Our ref: 680623 L02  
Application ref: 22/03873/F

**Installation and operation of a renewable energy generating station comprising ground mounted photovoltaic solar arrays and battery-based electricity storage containers together with substation, switchgear container, inverter/transformer units, Site access, internal access tracks, security measures, access gates, other ancillary infrastructure and landscaping and biodiversity enhancements.**

I refer to the consultation response from Oxfordshire County Council LLFA dated 27th February 2023. The below details how the additional impermeable areas from the development have been calculated and the measures proposed to manage surface water.

**Figure 1: Inverter Building Specifications**

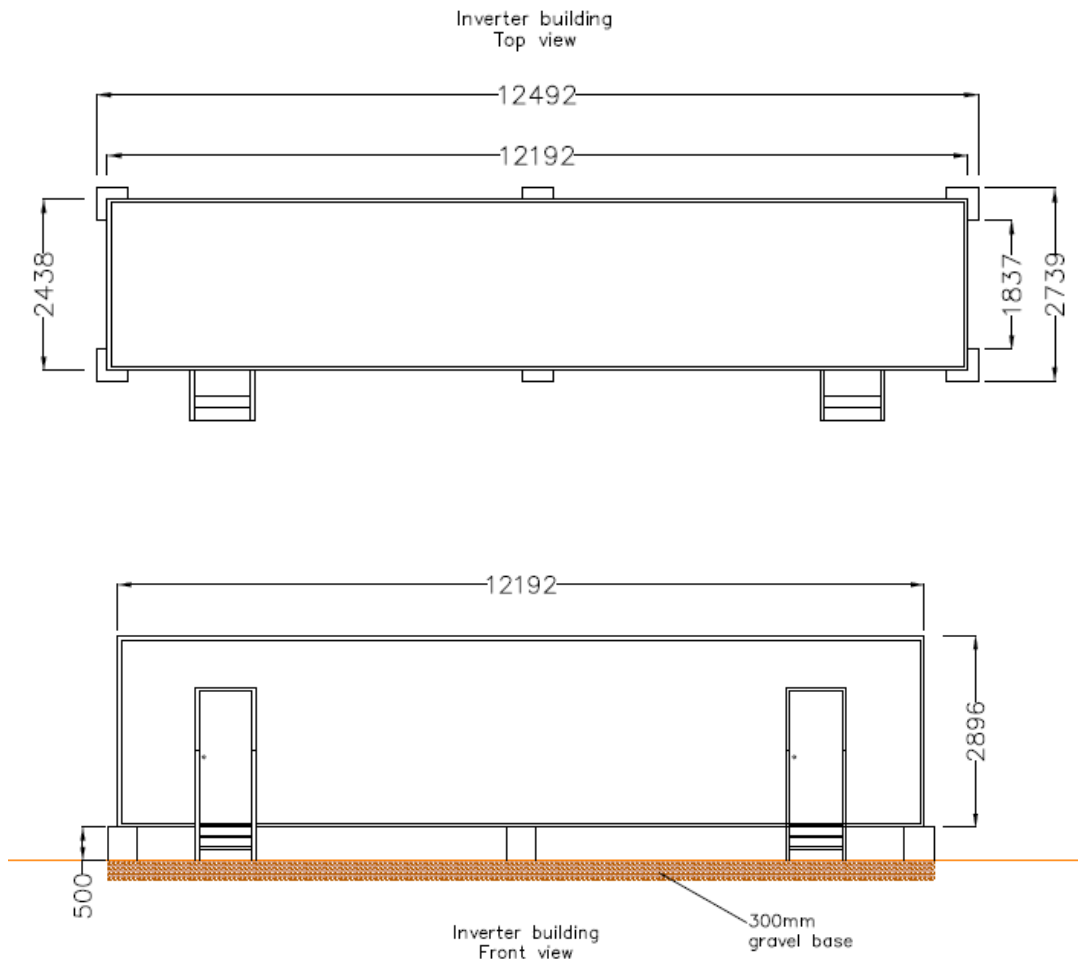
- Drainage strategy drawing required - Drainage drawing required to illustrate the permeable surface for the access roads and all other permeable surfaces.
- Permeable road construction detail to be provided - Construction details drawing to be provided for the permeable surface.
- Surface water flood exceedance plan to be provided - Provide surface water flood exceedance plan, illustrating that all surface water will be kept away from structures and within the site boundary.
- Maintenance regime to be provided for the permeable surfaces - Provide maintenance regime for the proposed SuDS features.

**Figures 1 – 3** show a top-down and side-elevation plan for the inverter units, spares containers and battery storage units. All units are shown to be raised above the existing ground levels on 500mm plinths/blocks and also allow for a 300mm deep gravel subbase for the units proposed at Padbury Brook.

**Figure 7: EA 100 year surface water flood depths (northern section of site)**

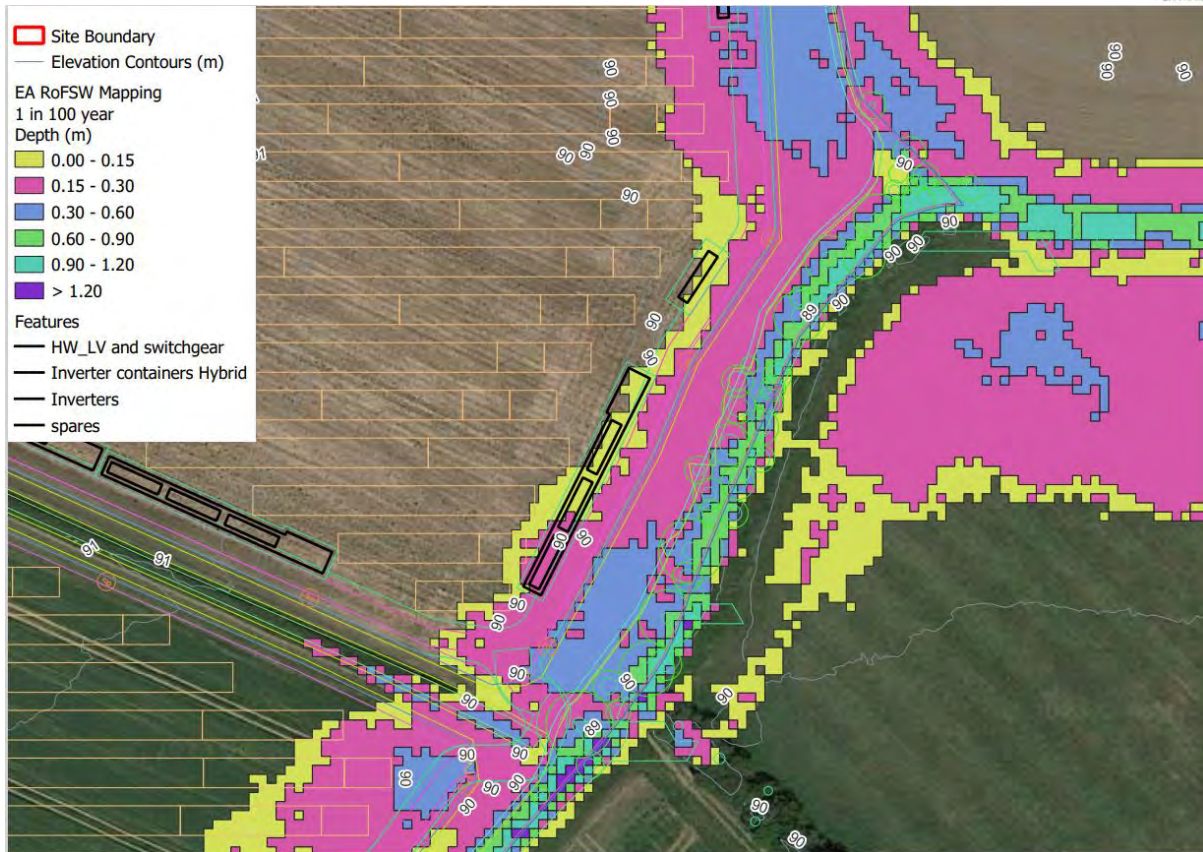
With respect to the third point raised by OCC, the LLFA plan notes that a surface water exceedance plan should be provided illustrating that all surface water will be kept away from structures and within the site boundary. As noted above, the structures on site (PV panels, inverters, spares cabinets and battery storage elements) are raised a minimum of 500mm above the existing ground level. To justify that the development will have no adverse impact on surface water flows (beyond the surface water drainage philosophy outlined above) the EA's surface water depth mapping for a 100 year event has been considered in greater detail. **Figures 5 – 10** below provide the banded surface water flood depth with relation to the overall site and site specific features.

The EA's surface water mapping shows a flow path running through the central field on the site. The development proposes a series of rows of PV panels within this field crossing the flow path. The surface water flood depths in this field in the vicinity of the panels are shown to be typically <150mm and not shown to exceed 300mm, a level below the toe of the solar panels. With minimal on ground structures (excluding piles) these PV panels in this location will not be adversely impacted by the surface water flow path, nor result in any changes to the flow path or the local depths.
